**PLANNING COMMISSION MEETING
MUNICIPAL CENTER COUNCIL CHAMBERS
Tuesday, May 5, 2009**

2. Preliminary and Final Site Plan Approval for the Germantown Fire Station no. 4

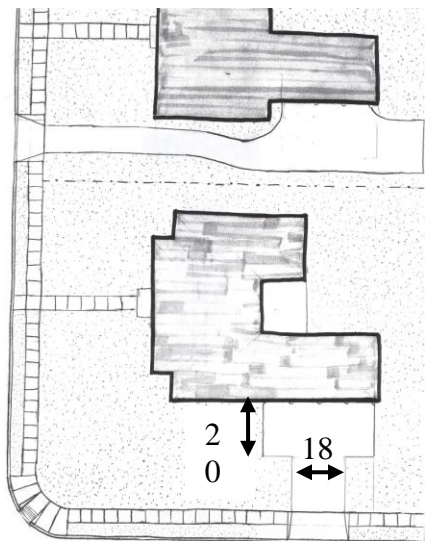
- i. The Drainage Plan should be designed to the 25-year storm.
- ii. Plastic drain fixtures should not be used. All drainpipes shall be A2000.
- iii. Explain where the trench drain in front of the bay drains to.
- iv. Grading in front of the fire station and on the trench drain appear to be only 3 in. below FF; explain;
- v. Show the ridgelines on the plan;
- vi. Indicate where storm-water goes;
- vii. Include the irrigation cisterns in the plan;
- viii. Drain structure no. 6 should be extended all the way to the drainage basin.
- ix. Oil and water separators are needed for the bay drains.

- i. Use TDEC erosion control details.
- ii. Show the typical TDEC construction entrance detail on the plans and location other than previously submitted.

- iii. The proposed wattle is not required in front of the spillway before the existing stormwater detention pond. Recommend removing the proposed wattle. During construction activity, the existing stormwater detention pond will act as the sediment basin. Require that the Engineer mark (survey by an RLS) the elevation of the existing pond before construction begins (report existing elevation to City of Germantown) and mark (survey by an RLS) the elevation after construction (report after construction elevation to City of Germantown). “Community Development” (CD) will determine whether the contractor is to a) Flocculate, pump and dredge the existing stormwater detention pond to the original elevation before construction started or b) Just flocculate the existing pond

- iv. Total acres needs to be labeled on the plans. Total amount of disturbed area should be provided and labeled on the plan. If more than 1 acre this site will require an NOC approval

- i. The taps for the bay drain and sewer should be separated.
- ii. The water tap should connect to the 20-inch main, using ductile, class 350 pipe.
- iii. The new 8 in. water main along the north property line should be moved out of the utility easement and into a dedicated easement.

- iv. Place all water mains within water easements.
- v. Show all utility connections;
- vi. Show all existing utility lines and tie-ins;
- vii. Show the demolition of the existing water line;

- viii. Show the size of the existing water main in Forest Hill-Irene Rd.
- ix. Show the location of the existing fire hydrant at the rear of the building.

- x. The existing 2 inch water service and meter should be used for the new building.
 - xi. Water service and fire service for the building can be provided from an 8-inch line in the driveway.

- xii. The existing main in Forest Hill-Irene Rd. is 20 in.
 - xiii. Show the isolation valves on the water line.
 - xiv. Show the existing sanitary sewer line on an existing conditions plan and indicate if that service is to be abandoned?

- d. Show the driveway aprons per standard Germantown design, not the city of Memphis.
- e. A 2-inch tap for the Training Building must be tied into the new main with a new valve box.

- f. The equipment bay sewer drains must be separated from the residential sewers, as the drains may often become blocked by debris.
- g. Proofread the notes on the Final Site Plan. Note five has inconsistencies in the numbers. No. 8 is not applicable.

- h. Provide details on the proposed irrigation cisterns. What will drain into them?
- i. Sidewalk drains should be avoided if possible.
